IN THE MATTER OF:
DAVIS BESSE INCIDENT

Discuss Additional Information Request: Serial 517 letter;
Flows for AWF, SUFW, Makeup, HPI, HPI/LPI Piggyback; CWD's
for MSIV's, 599/608, AFP Turbine Steam Valves.

DATE: July 9, 1985

MEETING BETWEEN THE NRC FACT-FINDING TEAM AND TOLEDO EDISON
TO

HPI PUMP

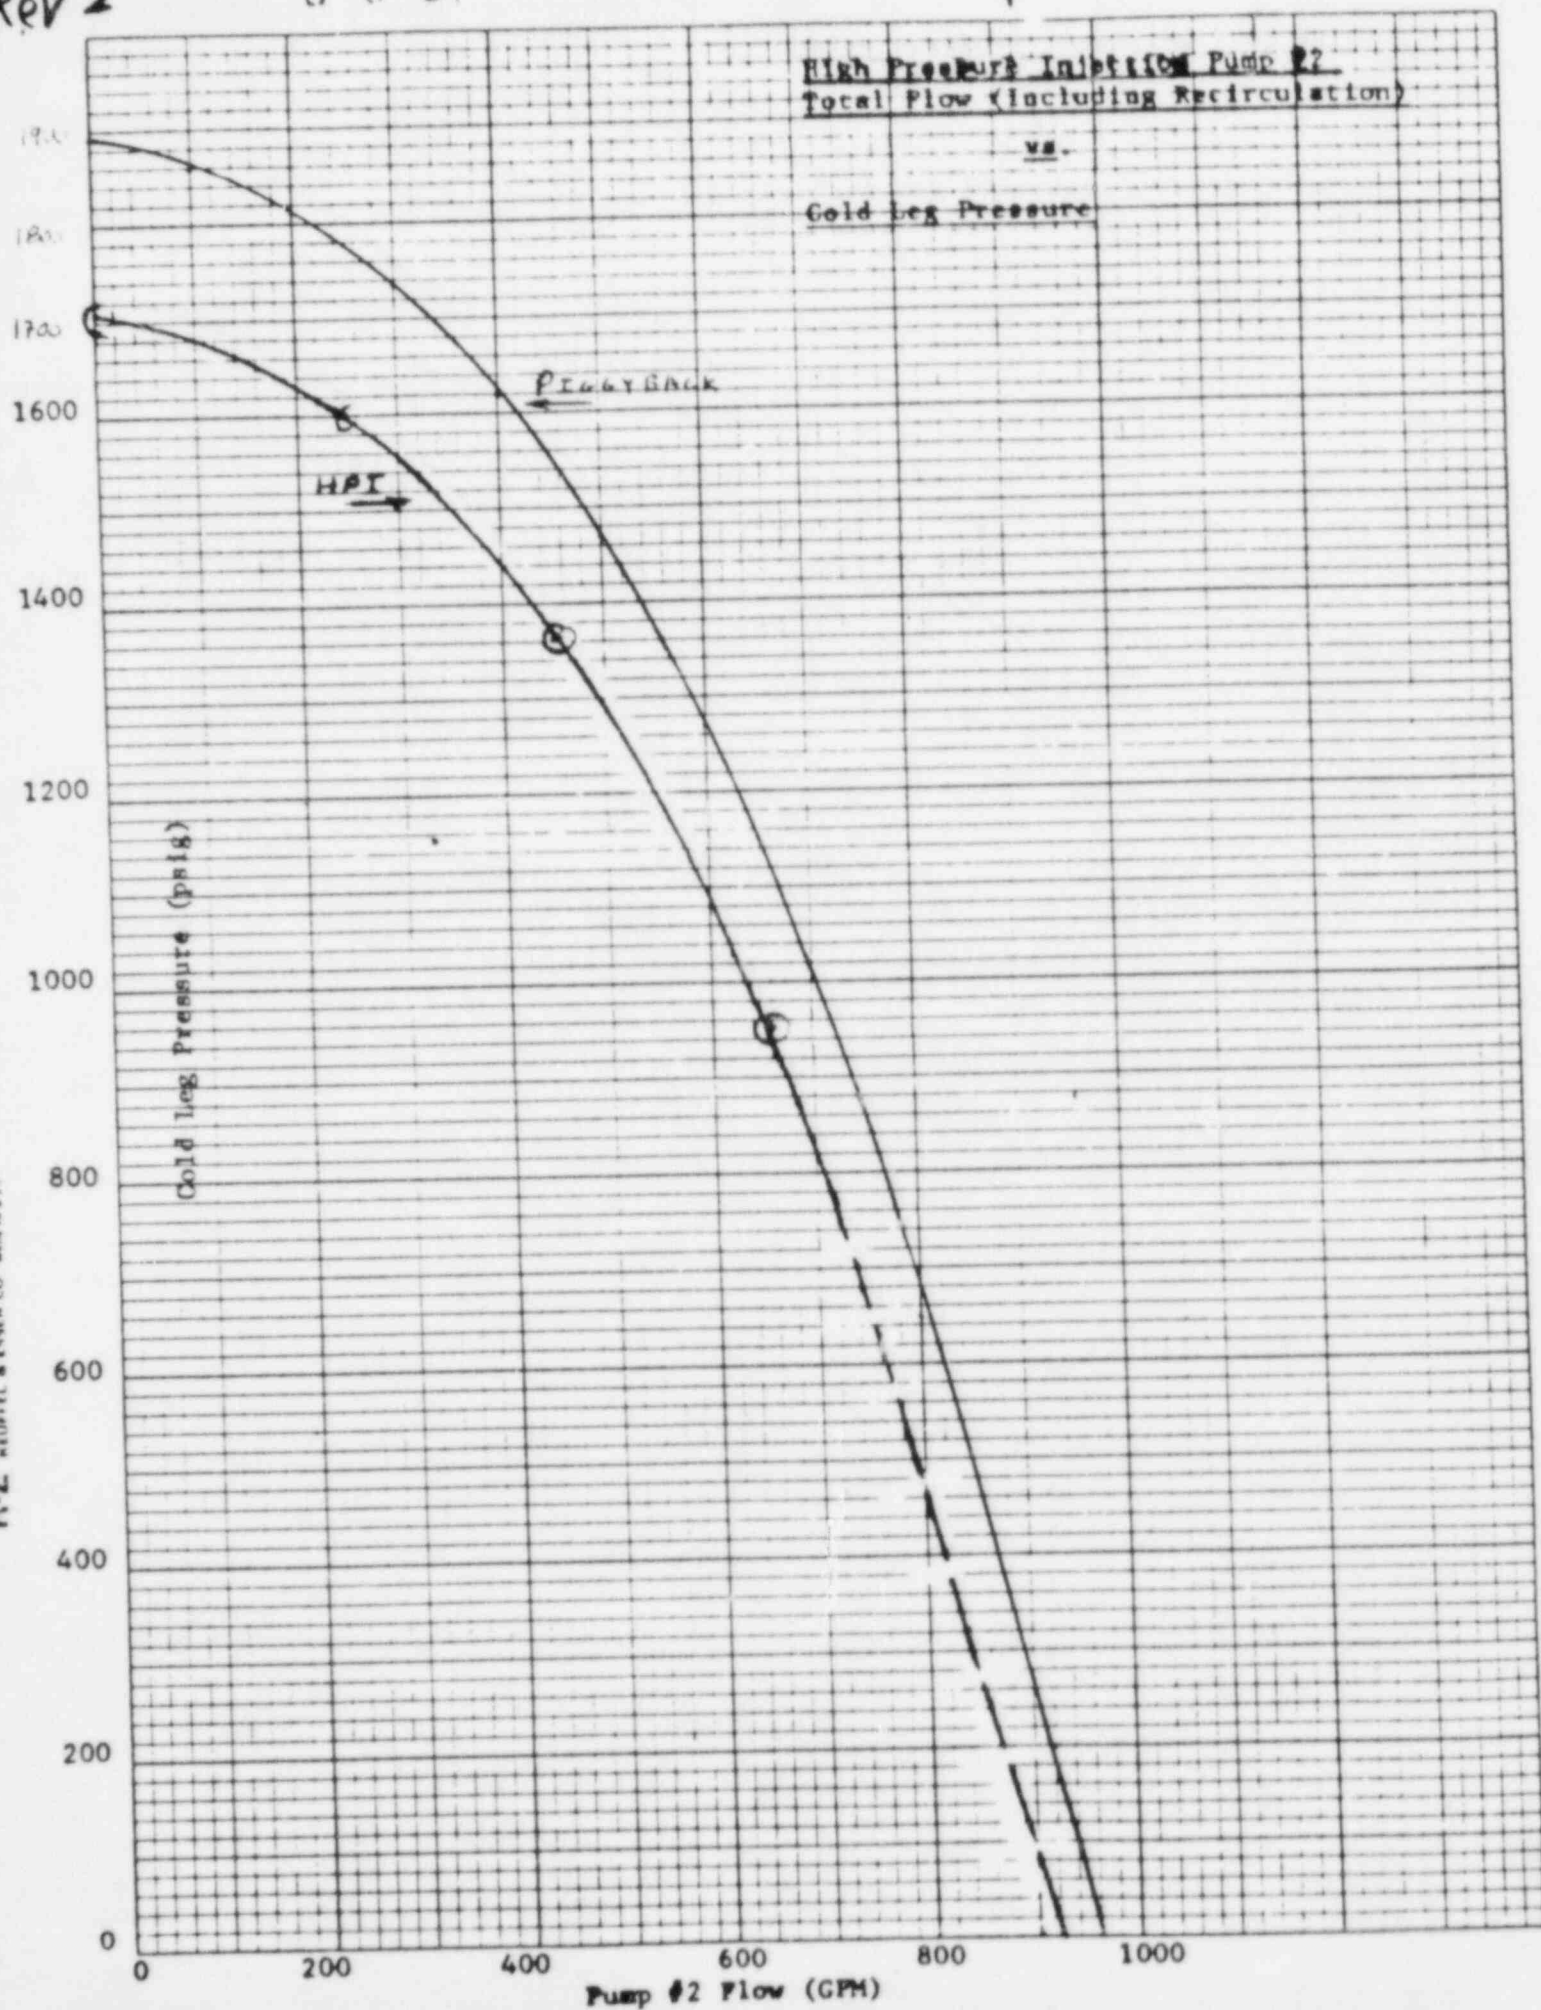
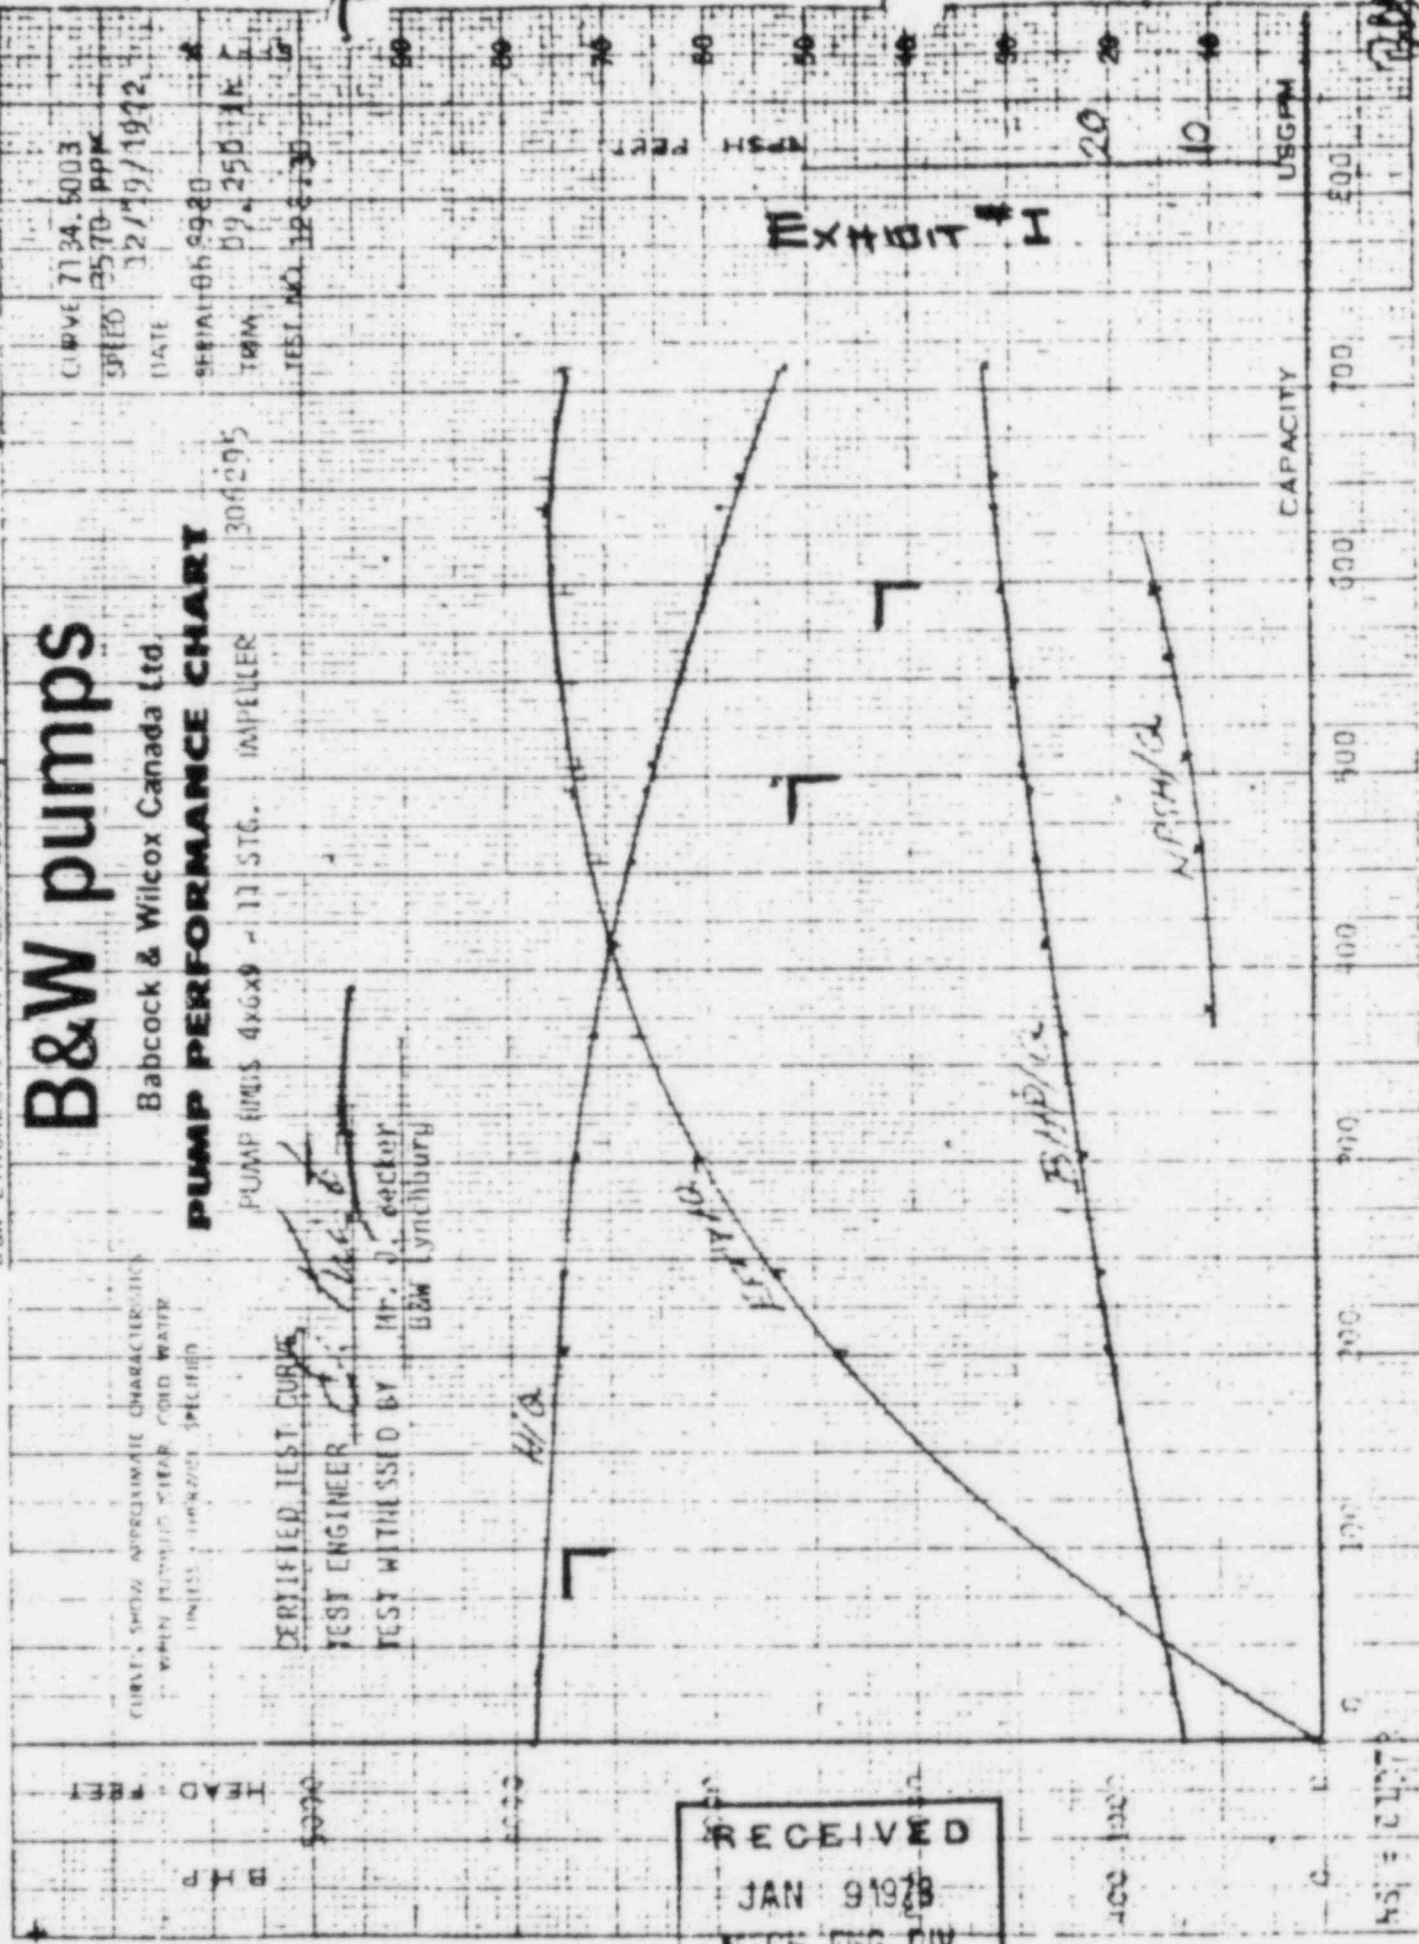
10 MR. ROSSI: And we have now verified what we under-
11 stood about the aux feed pump flow and pressure. Now the
12 high pressure injection pumps, the safety related high
13 pressure injection pumps, we have for those that they have a
14 shutoff head without being piggybacked of 1630 psig, that that
15 is basically the shutoff head when they are not piggybacked,
16 and when they are piggybacked, they are 1830 psig.

16 MR. BEARD: Can you just read the numbers of
17 the shutoff heads?

22 MR. ROSSI: That is for the lowest head pump?

17 MR. DONNE: That is about correct. Bechtel went
18 back and did a system resistance curve for the HPI back in
19 May of 1979, and they did it for both lines using the tested
20 pump curves for both pumps. There is some slight difference
21 in the tested characteristics of the head curve for the two
22 HPI pumps that were tested. The 1630 is the one with the
23 lowest head, which is high pressure injection pump No. 1.

18 MR. DONNE: Okay. For pump No. 1, for HPI injection
19 it shows around 16 ---

21 MR. DONNE: Okay. 1830.

23 MR. DONNE: The lowest head pump, yes. The second
24 pump where we have a slightly higher HPI shutoff head, the
25 piggyback goes up to around 1890. The shutoff head in

14 MR. DONNE: They didn't have it, but yesterday
15 we went in and basically superimposed upon the HPI pump the
16 head developed by the decay heat pumps. And over the 0 to
17 1000 gpm programs, the head developed at the decay heat pumps
18 is pretty flat. So it is basically a constant Delta P, and
19 we superimposed that Delta P on the HPI curves that Bechtel
20 generated.

AFW FLOW TO S.G. VS S.G. PRESSURE--BOTH PUMPS @ 3600 RPM TO S.G. NO. E24-2

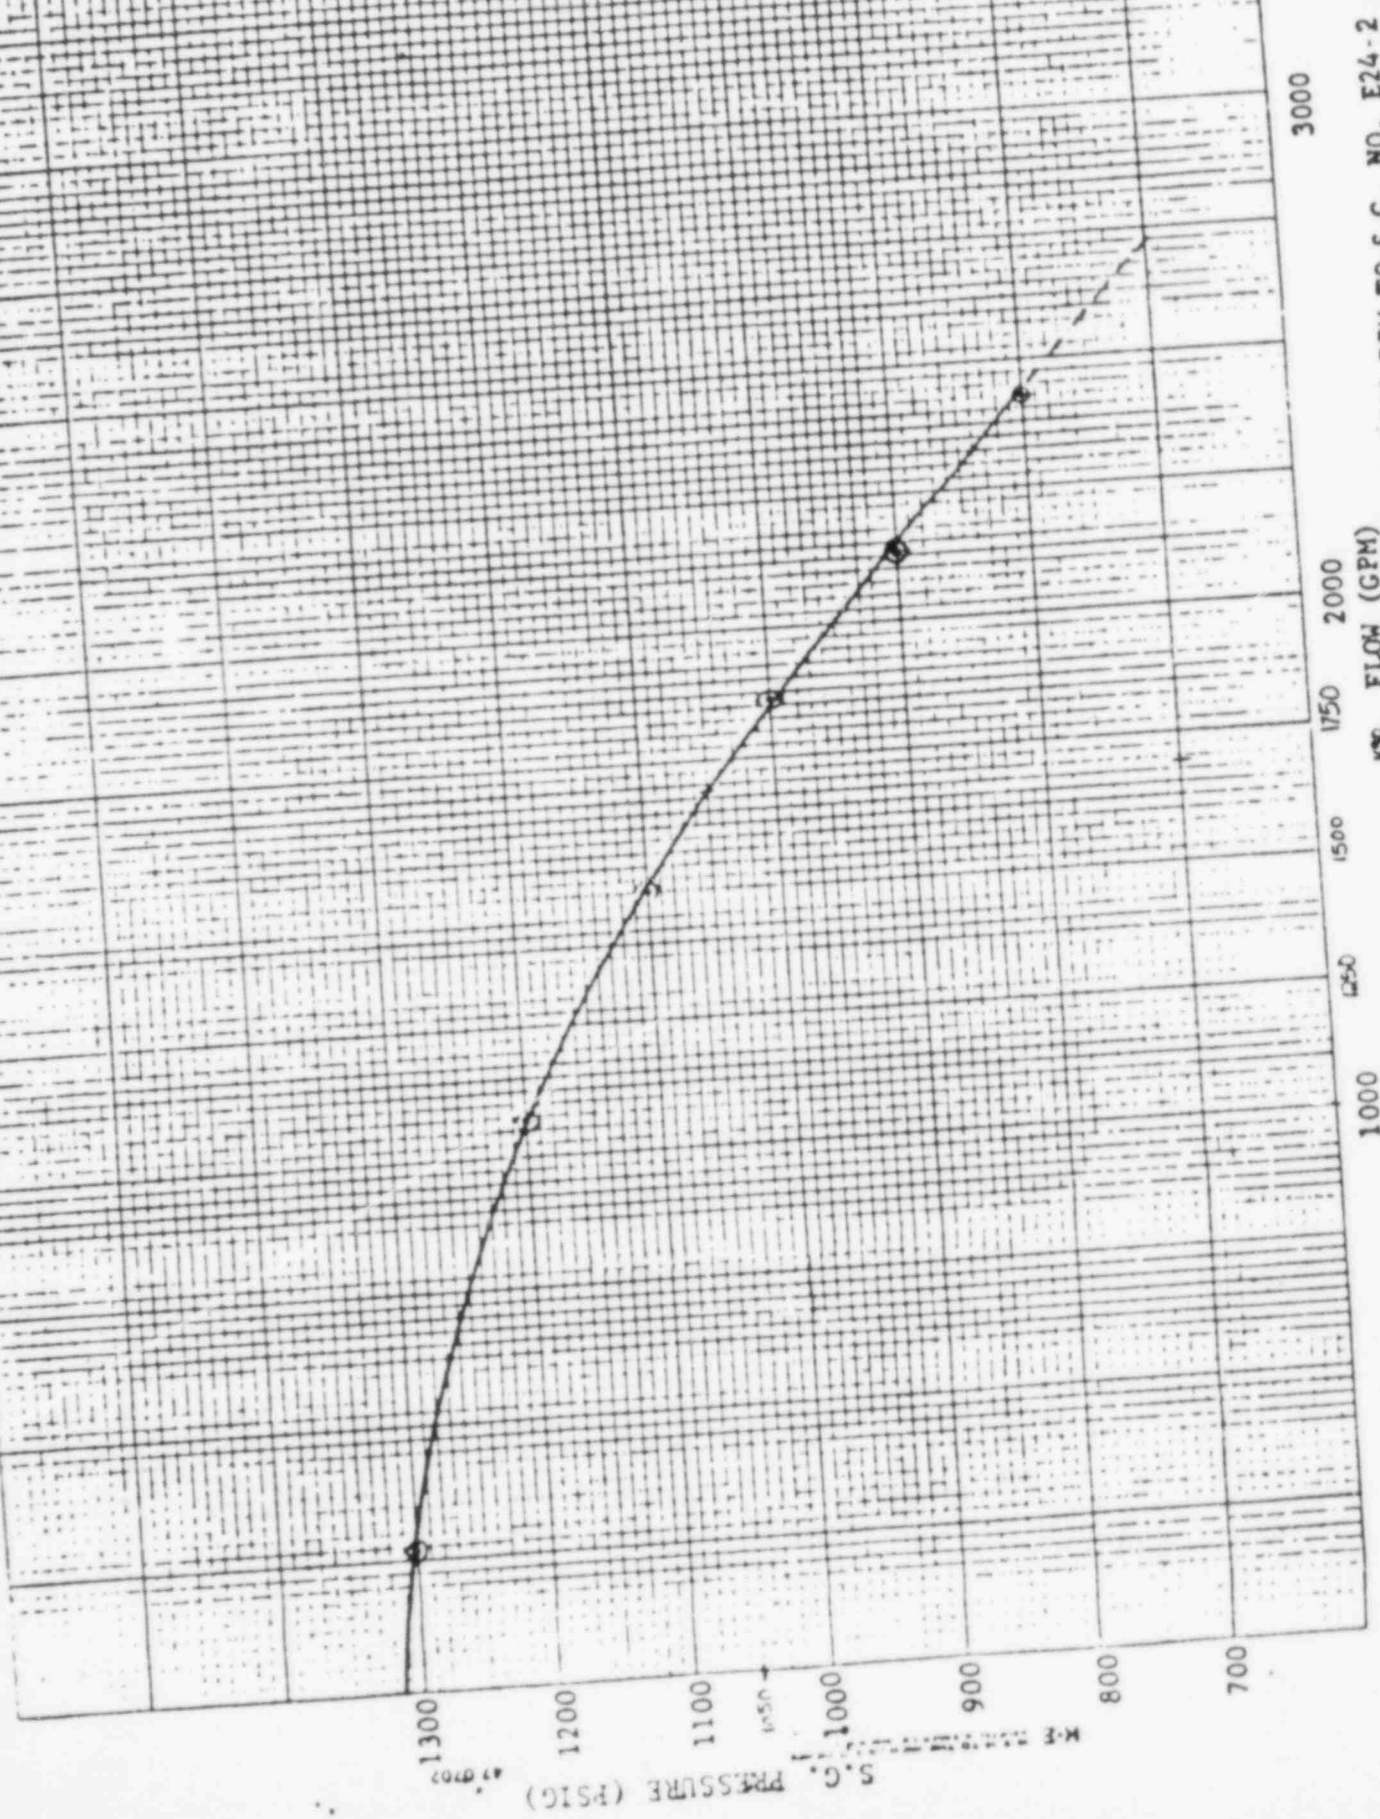
10 In any event, you are saying that at the safety
11 valve set point at 1050 psig that the aux feed pumps will
12 pump 800 gpm, each one will put in 800 gpm into the steam
13 generator and that the other 250 gpm is recirc?

17 MR. BEARD: Apparently this curve is for both
18 steam generators as a composite.

20 MR. BEARD: Because at 1050 it shows around 1600.

14 MR. DONNE: Right, and that curve should be flowed
15 to the steam generator. So that curve does not have recirc
16 flow in it.

21 MR. DONNE: Around 1600, yes, and that is what
22 I think the "X" axis label says, flow to both steam
23 generators. So it is assuming both pumps. So to get the
24 flow for each steam generator you would just have to have
25 the air flow and keep the same steam generator pressure.
